**75W Modification of Part 3A Concept
Plan Approval**

MP10_0159

Mixed Use Development

Royal Far West, Manly

Figure 22 – Level 3 comparative diagrams (plan extract S75W – 1006)

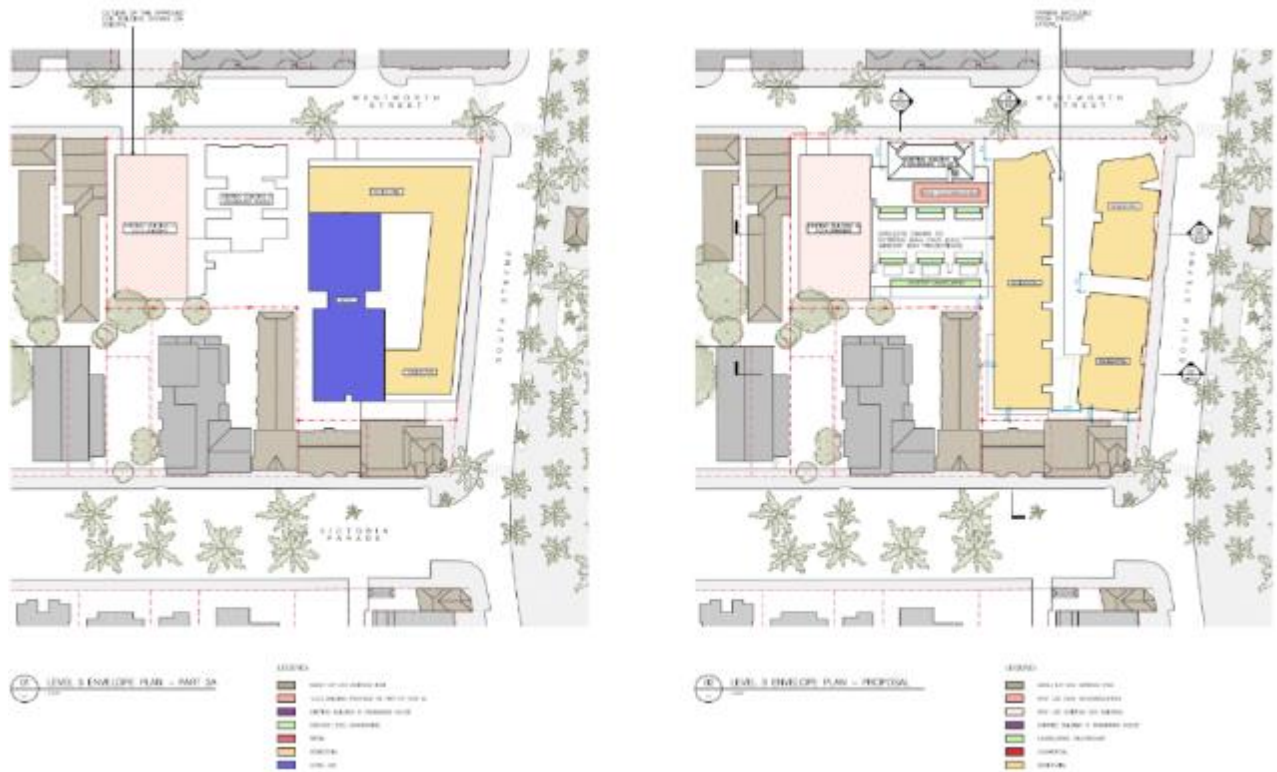
- The previously nominated hotel use is changed to residential at this level with the residential floor space redistributed and broken into 3 pavillions located around the central forecourt area,
- A small area of RFW guest accommodation is provided to the rear of the retained Drummond House roof form.
- The previously approved setbacks to Wentworth Street and South Steyne are generally maintained although both street facing facades provide for significantly greater visual articulation and relief through the introduction of the publicly accessible forecourt to Wentworth Street and the pavilion style building forms to South Steyne, and

- The residential floor plates are extended towards the southern boundary of the properties with the previously approved building envelope, where it adjoins this boundary, broken to provide for a continuation of the central forecourt space.

Figure 23 – Level 4 comparative diagrams (plan extract S75W – 1007)

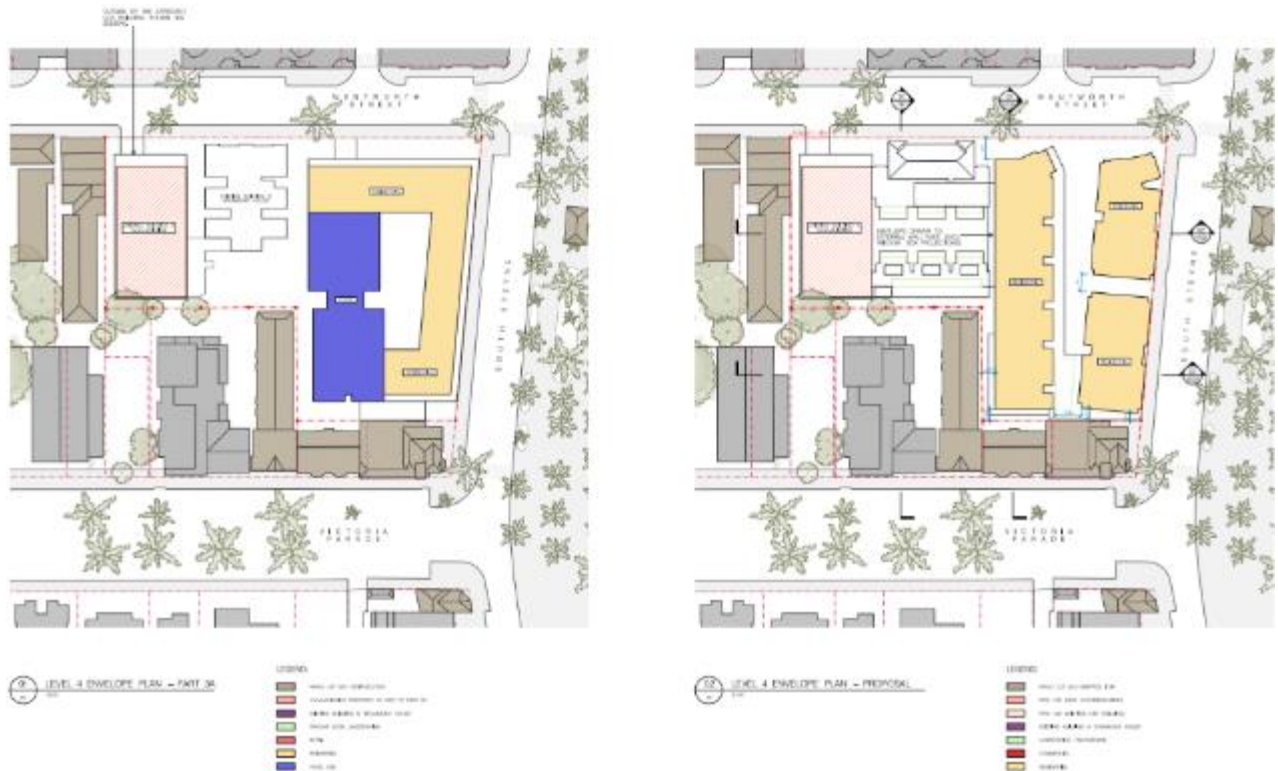
- The previously nominated hotel use is changed to residential at this level with the residential floor space redistributed and broken into 3 pavillions located around the central forecourt area,
- The previously approved setbacks to Wentworth Street and South Steyne are generally maintained although both street facing facades provide for significantly greater visual articulation and relief through the introduction of the publicly accessible forecourt to Wentworth Street and the pavilion style building forms to South Steyne, and

- The residential floor plates are extended towards the southern boundary of the property with the previously approved building envelope, where it adjoins this boundary, broken to provide for a continuation of the central forecourt space.

Figure 24 – Level 5 comparative diagrams (plan extract S75W – 1008)

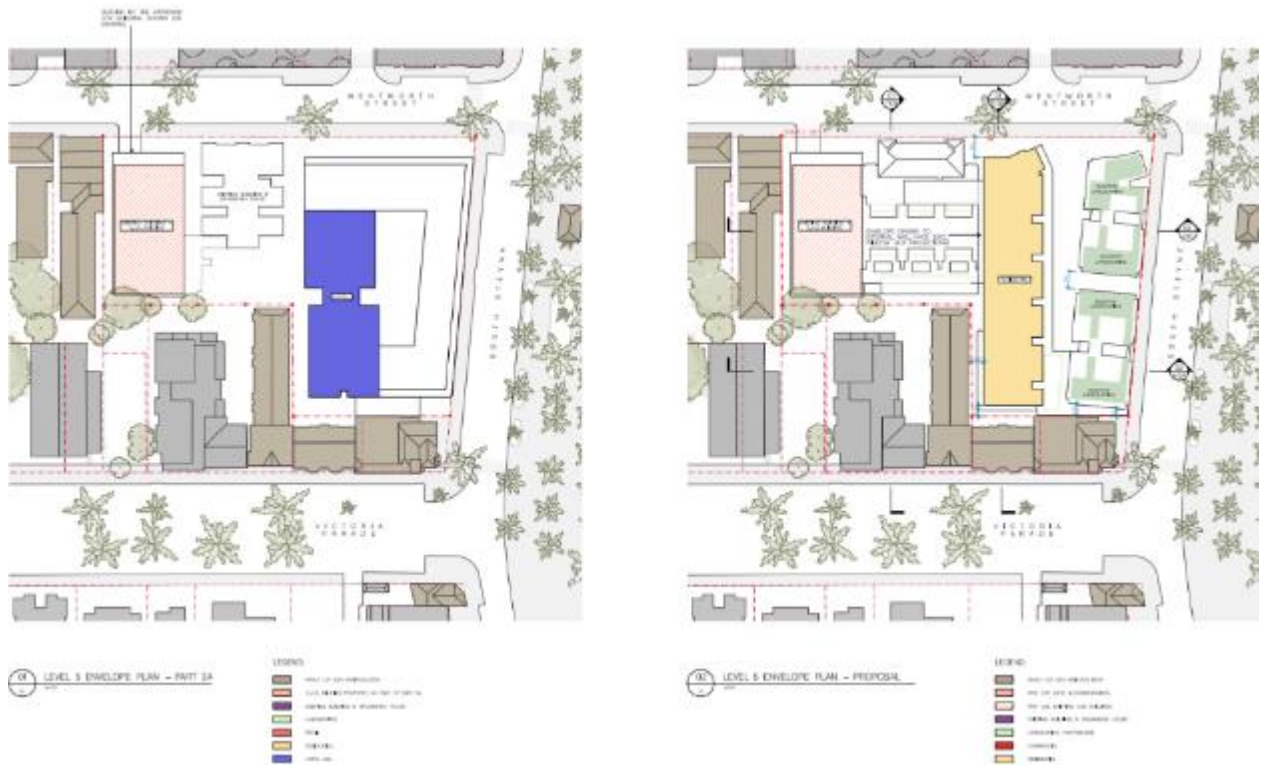
- The previously nominated hotel use is changed to residential at this level with the floor plate extended towards the Wentworth Street frontage,
- Rooftop landscaping is introduced to the South Steyne fronting pavilions with these roof elements having a maximum parapet height of RL 22.6 with roof top stair and lift access not exceeding an RL of 24.15.
- The side boundary setbacks are modified to accommodate the central forecourt area.

Figure 25 – Level 6 comparative diagrams (plan extract S75W – 1009)

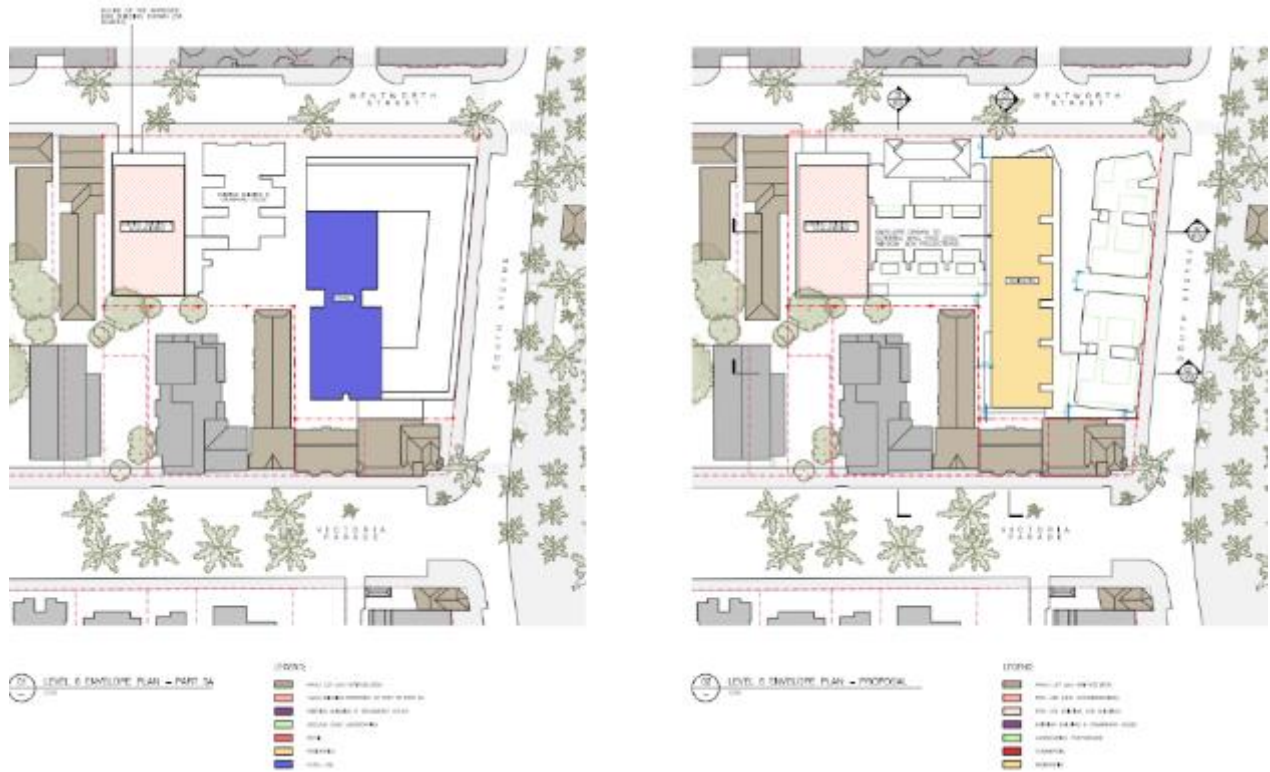
- The previously nominated hotel use is changed to residential at this level with the floor plate extended towards the Wentworth Street frontage, and
- The side boundary setbacks are modified to accommodate the central forecourt area.

Figure 26 – Level 7 comparative diagrams (plan extract S75W – 1010)

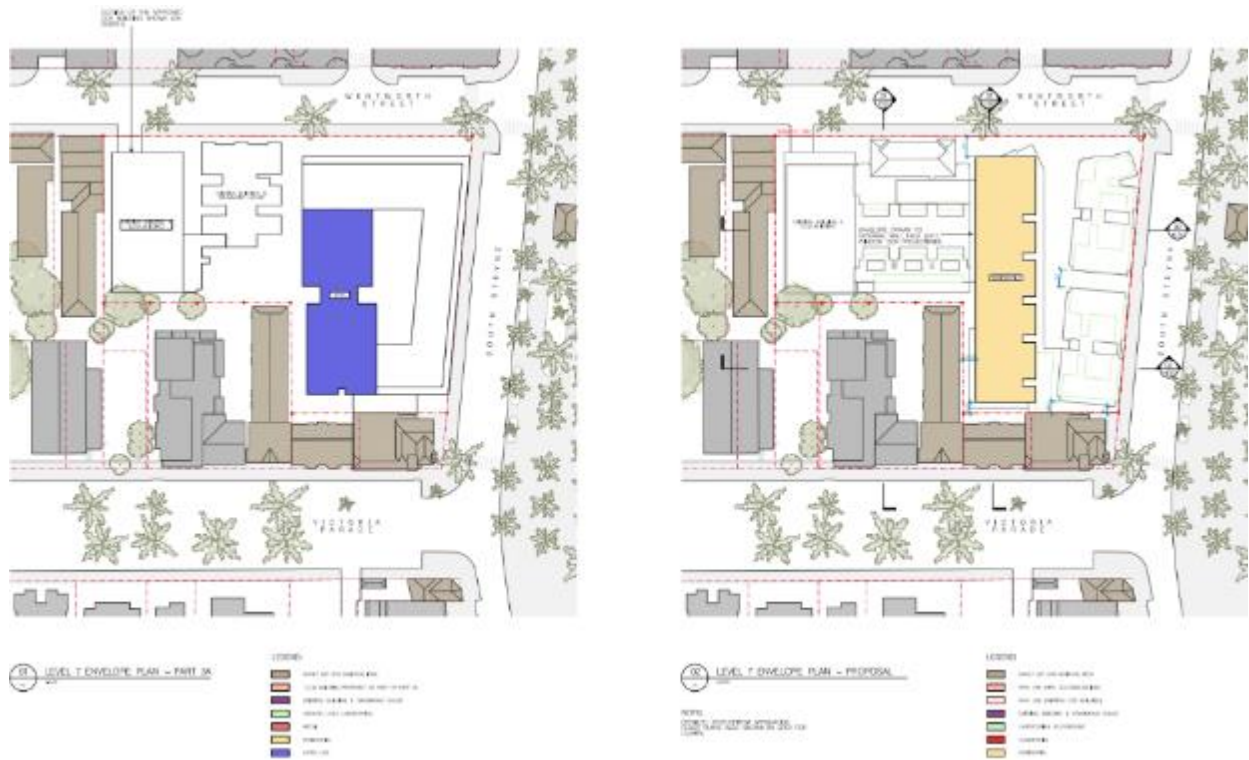
The modifications at this level are the same as those for Level 6.

Figure 27 – Roof Level comparative diagrams (plan extract S75W – 1011)

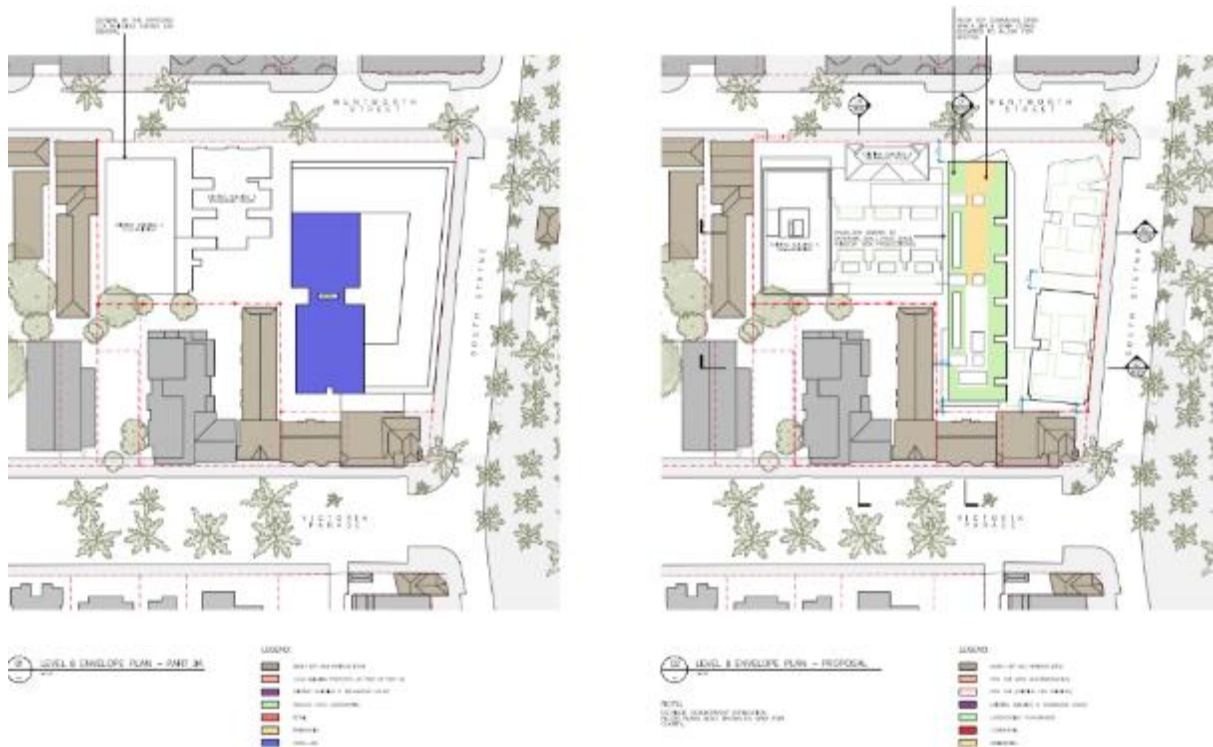
- The previously nominated hotel floor plate at this level is deleted in accordance with the PAC report and replaced with roof top communal open space associated with the residential component of the proposal,
- The roof is extended towards the Wentworth Street frontage, and
- The roof top planter elements have a maximum parapet height of RL 32.00 with roof top structures, including necessary plant equipment, access stairs, shading devices and lift structures not exceeding a maximum height of RL 32.9, RL 33.4, RL 34 and RL 35.15 respectively.

Figure 31 – Ground level landscaped area comparative diagrams (plan extract S75W – 1070)

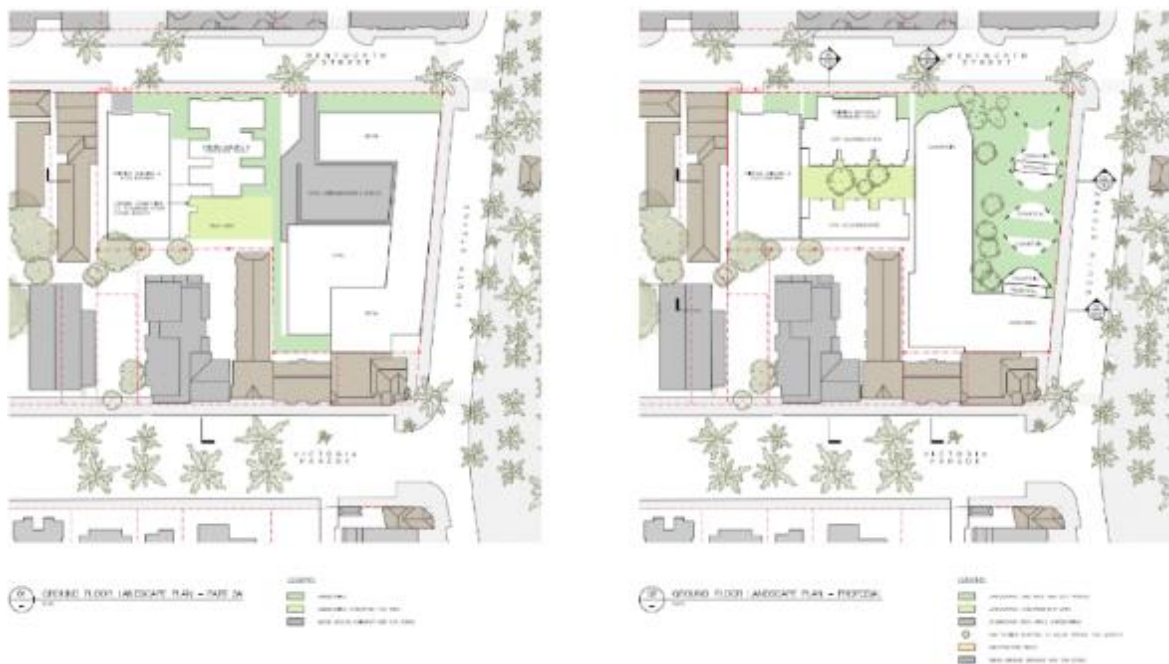
Figure 31 below provides a comparison between the Concept Approval landscaped area arrangement and the section 75W modified arrangement with Figure 32 over page depicting the additional roof top landscape zones proposed as a component of the section 75 modification request.

Figure 32 – Plan showing additional roof top landscape zones (plan extract S75W – 1060)

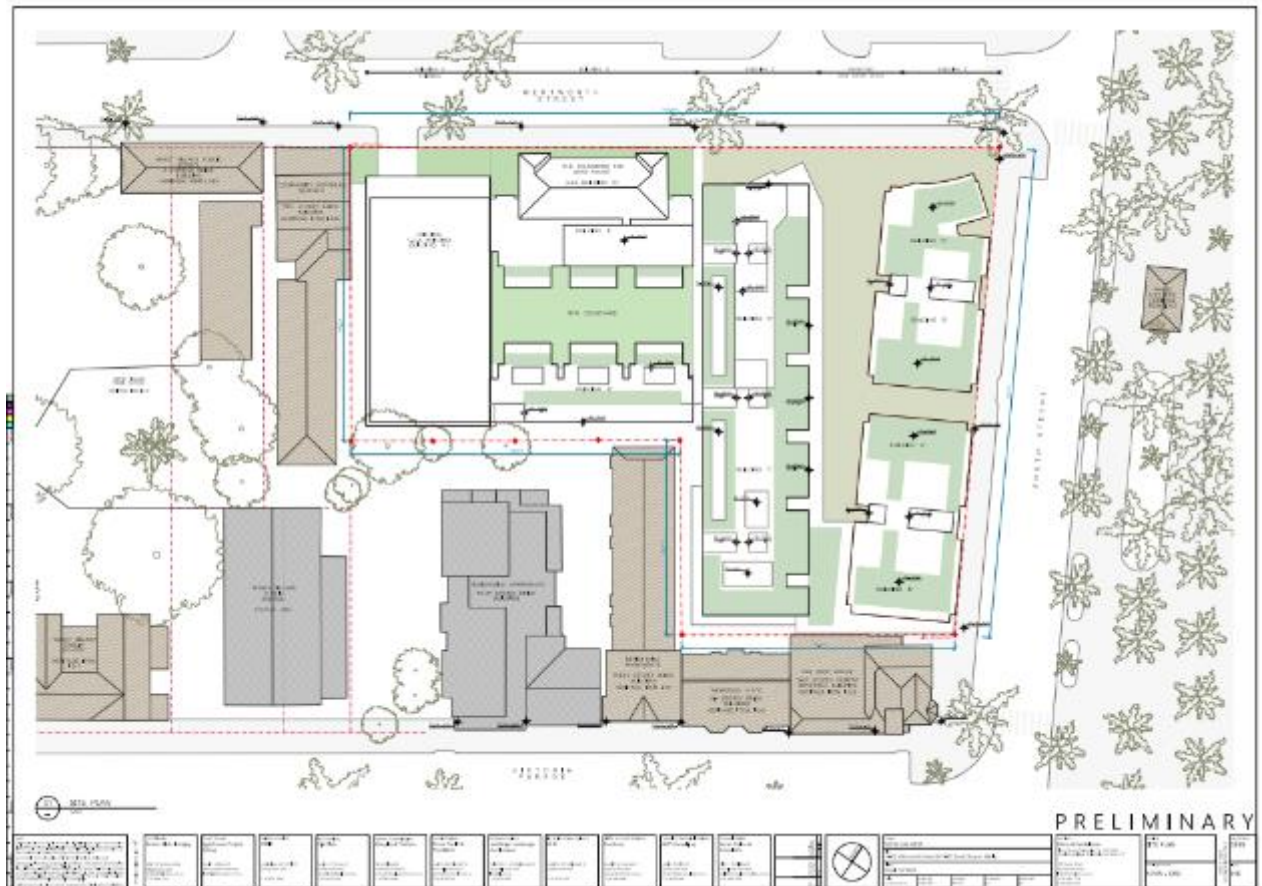
We consider the landscaped outcome for the site to be significantly enhanced as a consequence of the modifications sought including the provision of publicly accessible ground level landscaped forecourt space, appropriately located safe and secure private open space for RFW families and guests and the provision of appropriately located private and communal rooftop landscaped open space areas.
